Access Compliance Report Public Rights-of-Way (Curb Ramps)

Intersection ID: 12581 Main Street: GLENSTAR_TR **Cross Street: SUDBURY RD** Location: ADA ID: 4418C47F8C27 Ramp Type: Perp Initial Pass/Fail: Fail **Overall Compliance: No Severity Score:** 8.75

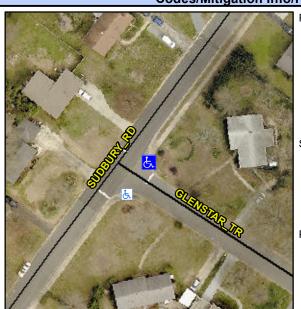
Possible Solutions: Remove & Replace Entire Ramp. Surveyor Notes: N/A PROW/ADA: Not Found, R304.5.1

| Field Measurements/Component Compliance | | | | | |
|---|------------------------|-------|------|-----------------------------|------|
| No | Ramp Width (in) | 45.5 | Yes | Ramp XSlope (%) | 1.4 |
